**SENIOR CENTER
15 LOUIS LANE
COLCHESTER, CT 06415
BID #2022-013**

S/P+A PROJECT #20.003

DATE: September 22, 2022

The following changes to the Drawings and Project Specifications shall become a part of the Drawings and Project Specifications; superseding previously issued Drawings and Project Specifications to the extent modified by Addendum #1.

Drawing Title:
SITE PLAN - GRADING

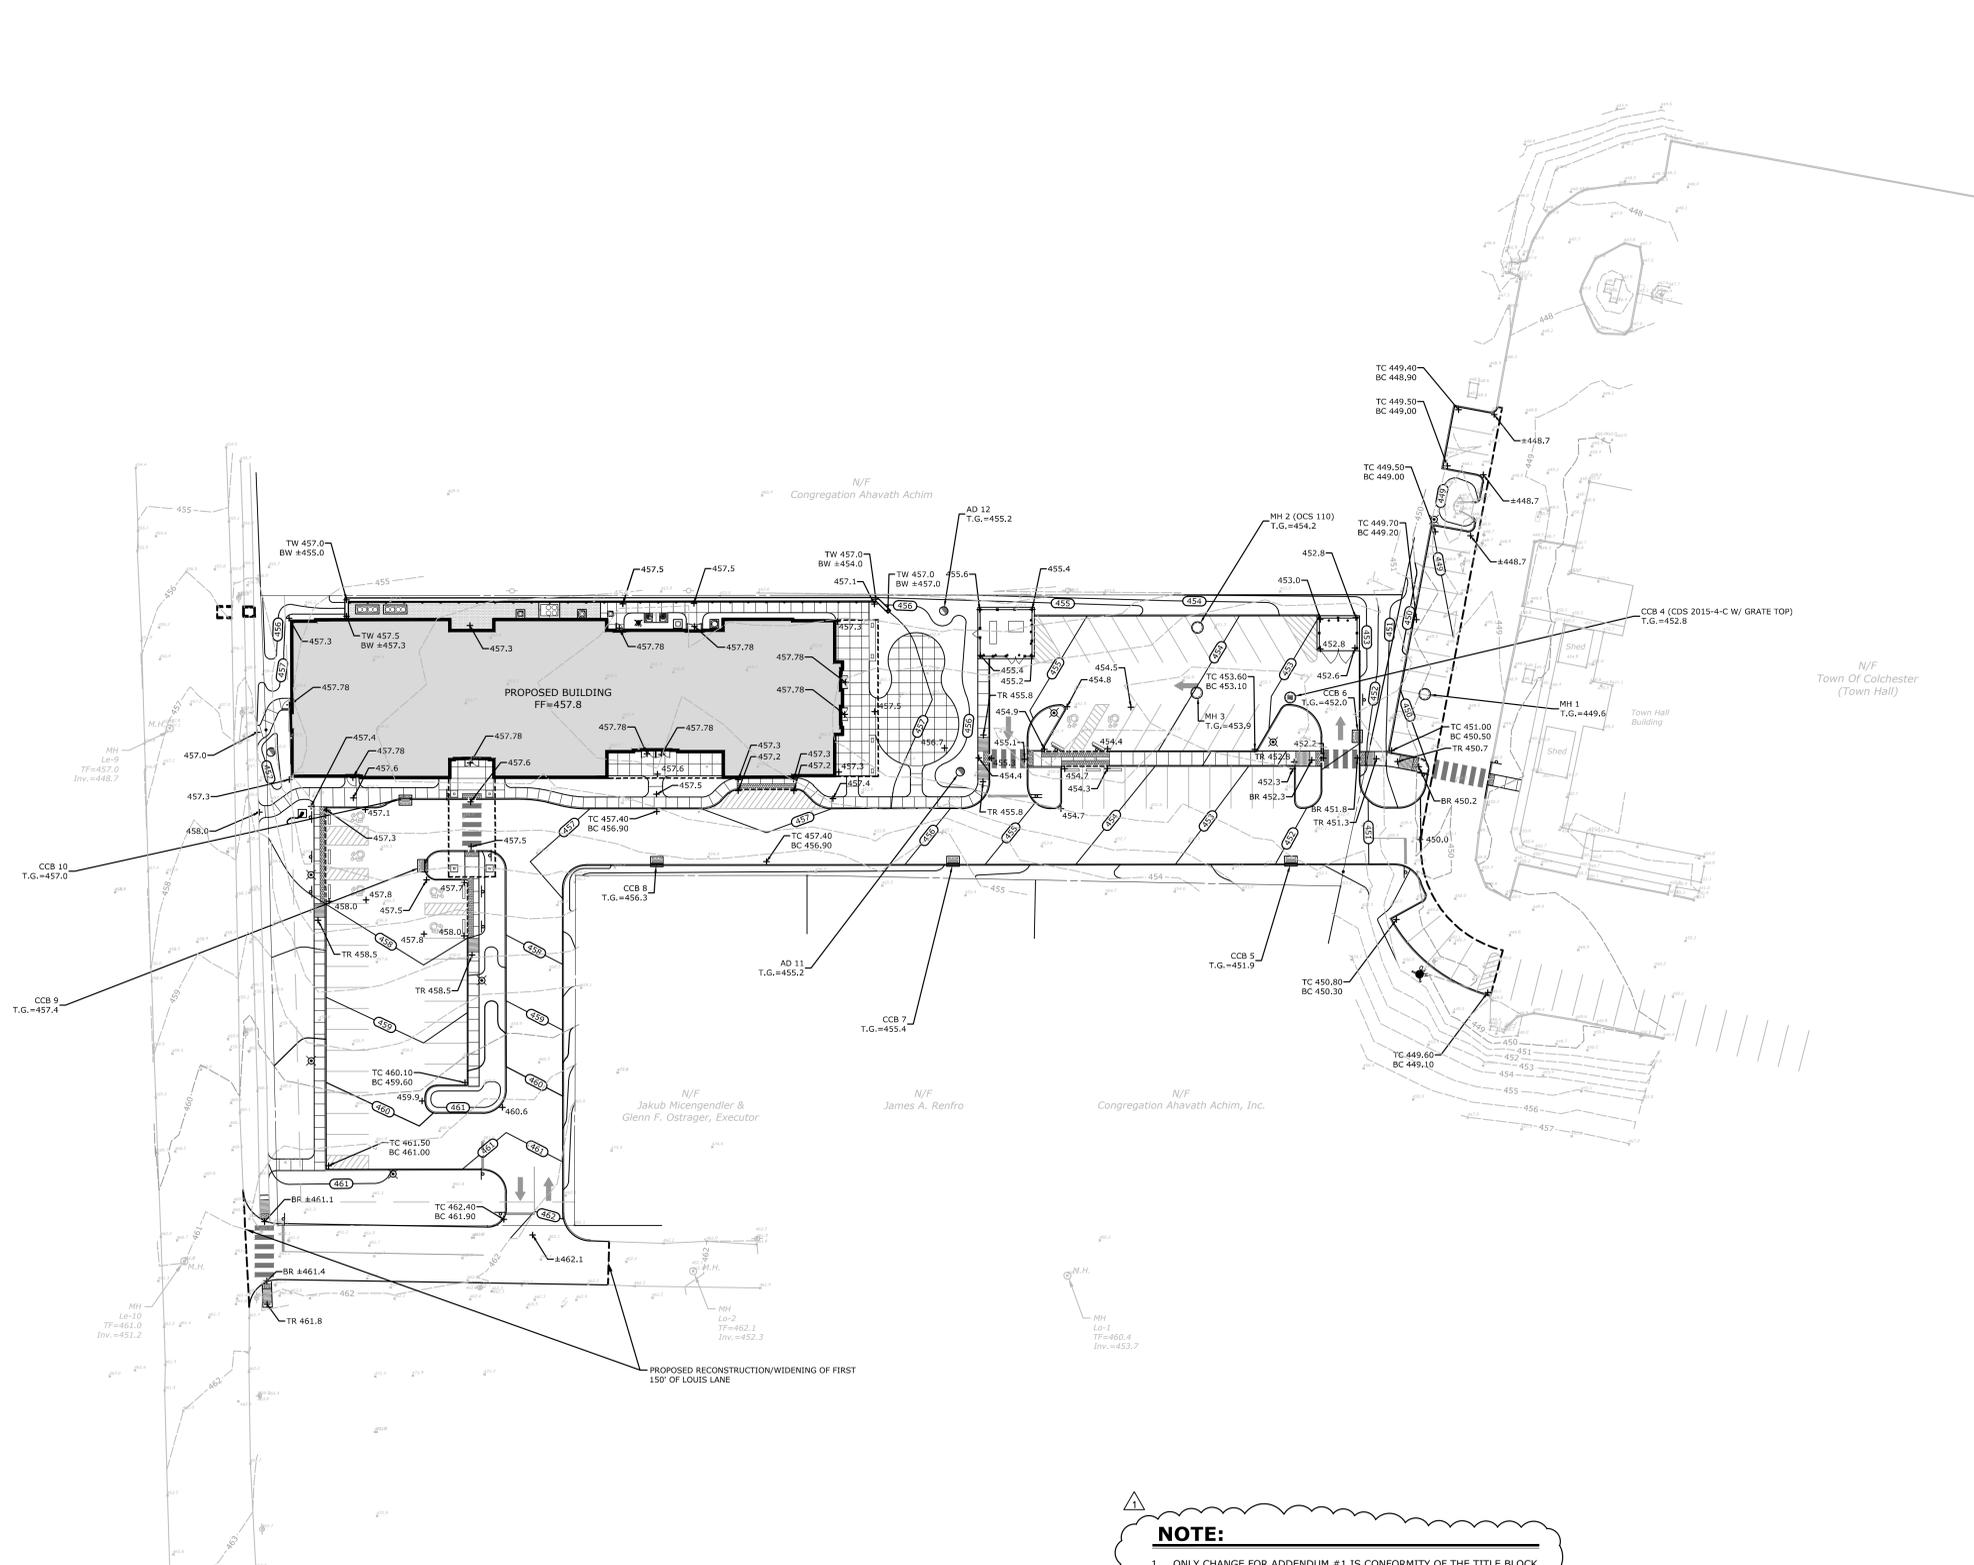
1. ONLY CHANGE FOR ADDENDUM #1 IS CONFORMITY OF THE TITLE BLOCK
